## SERVICE INFORMATION

## SI2019-010

## Regarding 8DB 355 013-301 (T1696) $\rightarrow$ 8DB 355 025-351 (T2635) / 8DB 355 025-361 (T2634) / 8DB 355 025-371 (T2637)

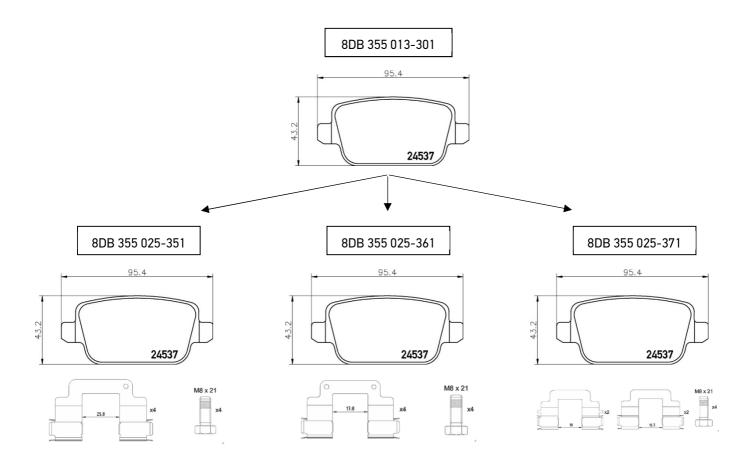
To optimize the product specification for the brake pad set 8DB 355 013-301 and in order to underline and follow the OE approach it was decided to add accessory kits to the set.

Depending on the vehicle specification different accessory kits are needed. In order to meet those requirements, the 8DB 355 013-301 has been split into three different part numbers, so that customers can easily choose the right part number for their needs.

8DB 355 013-301 will be replaced by 8DB 355 025-351 (incl. sliding shims with 25.8 mm gap), 8DB 355 025-361 (incl. sliding shims with 17.8 mm gap) and 8DB 355 025-371 (incl. sliding shims with 18.0 and 16.7 mm gap). Please see the differences in the pictures below.
